Bonneville-Hood River Transmission Line Rebuild Project Final Environmental Assessment

Bonneville Power Administration
DOE/EA-1981
June 2018

Changes made to the draft EA primarily include the addition of clarifying language, refinement of calculations for access road and trail activities and associated impacts, updates to the visual resource assessment based on refined project design information, and minor revisions to mitigation measures. These revisions are presented below by the chapter and section in which they appear in the Draft EA. Where text has been modified, deleted text is indicated as "strikethrough" format (~~strikethrough~~) and new text is underlined and highlighted in blue.

Bonneville-Hood River
Transmission Line Rebuild Project
Figure 2.2-1
Line Mile 19 - Option 1

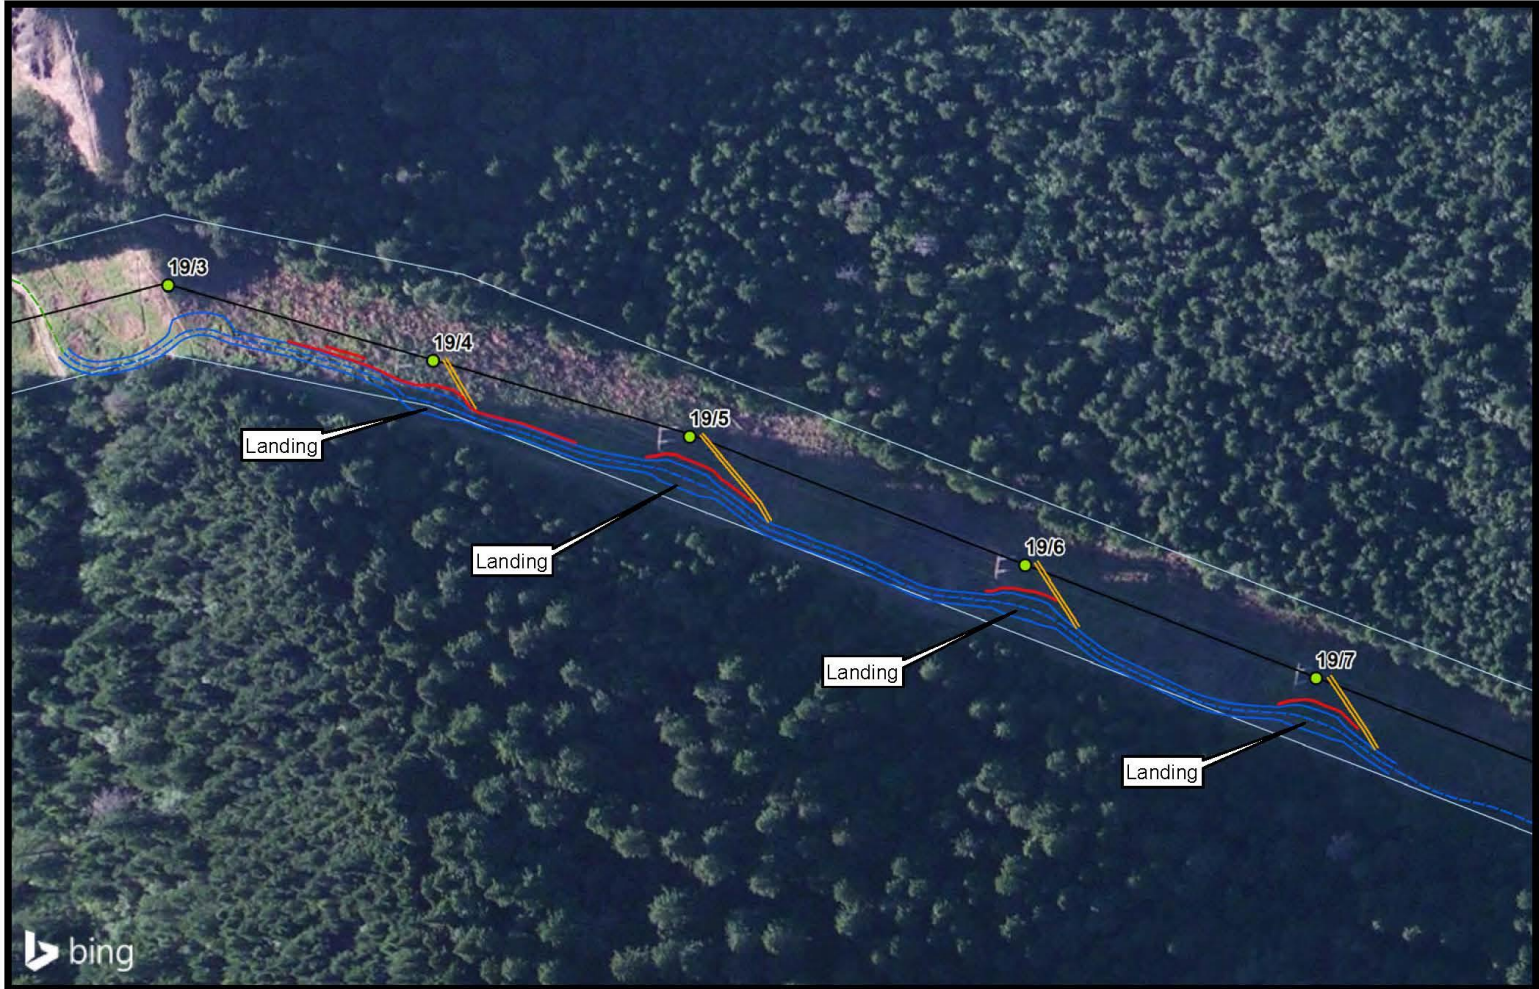
Figure 2.2-1 (Line Mile 19 – Option 1) has been revised so that it reflects the design changes described in the preceding paragraphs:

Under Line Mile 19 Option 1, BPA would reconstruct about 1,500 feet of the existing access road. BPA would regrade the existing road to level it out and to provide a uniform downhill slope from west to east. BPA also would widen the road by about 4 feet to provide a single, standard 14-foot wide travel lane. The finished road would be surfaced with a 4-inch depth of crushed rock surfacing aggregate, and downslope fills would be at maximum slopes of 1.5H:1V. Under this option, the road would be widened into the existing cut slope where cuts of less than 10 feet are feasible, minimizing the need for fill-side retaining walls. On each side of the first landing at structure 19/4 near the summit, where cut slope widening is impractical and a fill would not catch on existing steep slopes, fill-side (downslope side) retaining walls up to 5 feet high for a total distance of 100 feet would be required. These walls would be constructed with similar materials (Mechanically Stabilized Earth [MSE]) as described for the landings below.

In addition to this road reconstruction, four landings would be constructed using a portion of the existing access road along the road at points near the four transmission structures at Line Mile 19. to allow a bucket truck to be staged in a manner that construction and future maintenance crews could access the structure arms, conductor, and hardware. The existing access road would be graded to provide a uniform slope between landings. Due to the steep topography in the area, several MSE retaining walls would be installed on the downslope side of the access road and landings. These landings are necessary to allow BPA maintenance and construction equipment to physically reach the new structures from the access road. In addition, these landings would provide a safe workspace around maintenance vehicles where crews can temporarily stage materials and equipment. Each of the four landings would be about 80 feet in length and would taper out from the downslope edge of the reconstructed access road to a maximum width of 25 feet (i.e., 11 feet beyond the edge of the 14-foot wide reconstructed road) and then taper back to the road.

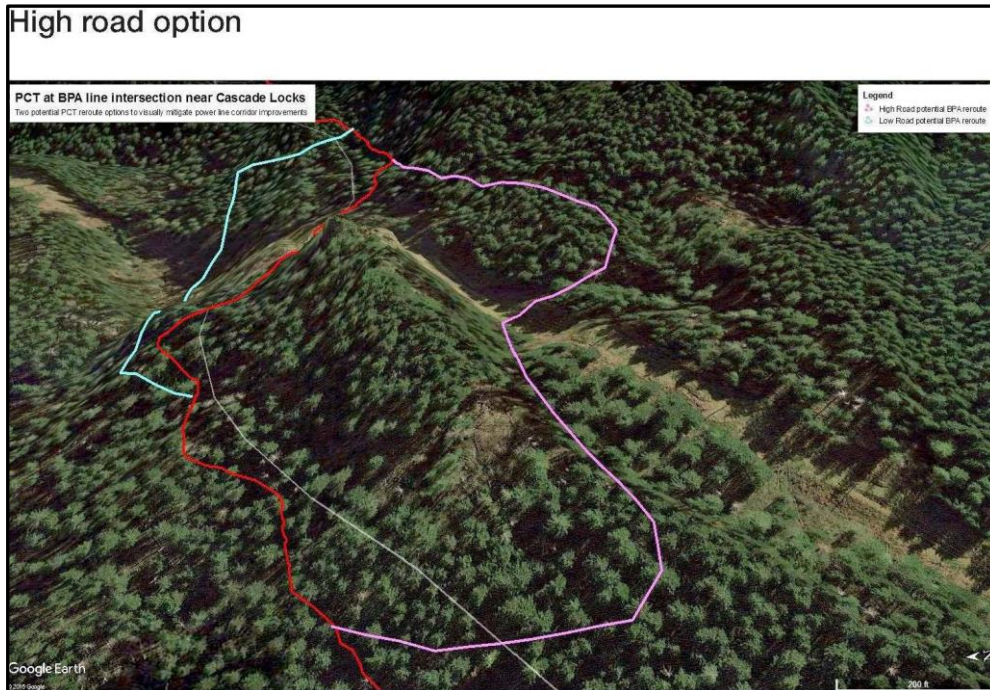
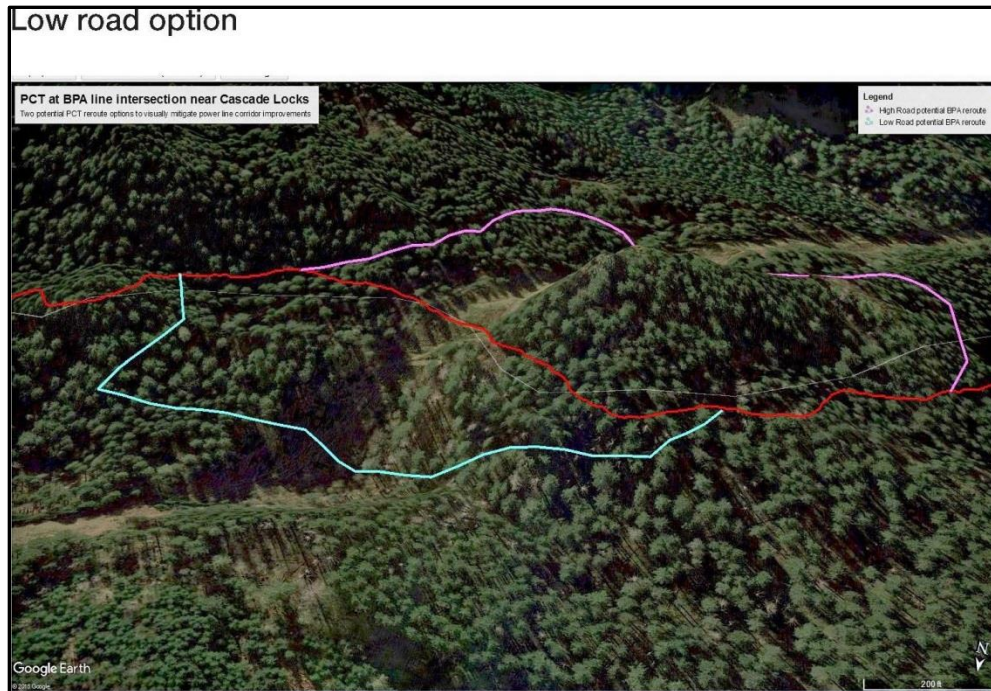
0010-4 The trail shares the BPA access road for about 225 feet, which is more than necessary to simply traverse the width of the utility corridor. While it's suboptimal for the Pacific Crest Trail to follow any road at all, at least the existing condition of the road is rustic. Upgrades to the road, including resurfacing with imported materials, will make it appear and feel more industrialized for the PCT traveler. A related effect, because the road is already dominant over the trail, is that people get lost and continue to follow the road, despite trail signage. Improving the road would exacerbate this situation.

0010-5 The trail crosses directly under one of the structures, in fact, between the poles and their guy lines. This site can't help but appear impacted by the proposed improvements. There will be three

poles instead of two, and, clearly a good deal of ground disturbance involved in upgrading this structure.

0010-6 These exacerbated visual impacts to the trail could be best ameliorated by reconfiguring the intersection, and reconstructing portions of the PCT where necessary to meet the BPA line in a spot that lends itself better to disguise. Such a trail relocation would be as much as .5 mile long, and would require its own NEPA study. We propose that this NEPA study, and subsequent trail construction by PCTA's volunteer crews, be funded by BPA as a mitigation measure.

0010-2 Comment noted. Sections 3.2, Recreation, and 3.9, Visual Resources, and Appendix C, *Visual Resource Analysis (Columbia River Gorge National Scenic Area)*, of the EA address potential recreation and visual quality-related impacts from the proposed rebuild project on the Pacific Crest Trail. As shown in Figure 3.2.1 of the EA, the Pacific Crest Trail passes under the existing transmission line near the urbanized area of the City of Cascade Locks, Oregon, approximately 0.5 miles southeast of the heavily travelled I-84 corridor. In order to maintain the existing experience for trail users as much as possible, BPA would limit work performed in the vicinity of the Pacific Crest Trail to the rebuild of one transmission structure. One other structure will remain as-is, and two structures would require replacement of a single pole. Access road work in this location would be limited to improving existing access roads in the area where needed with additional rock surfacing; no widening would occur. BPA also would implement several minimization and mitigation measures (see Table 2.7-1) to minimize project visible impacts to Key Viewing Areas, including the Pacific Crest Trail. These measures include minimizing vegetation clearing, using local rock and color treatment Permeon on access road rock, and revegetating with native seed mixes.
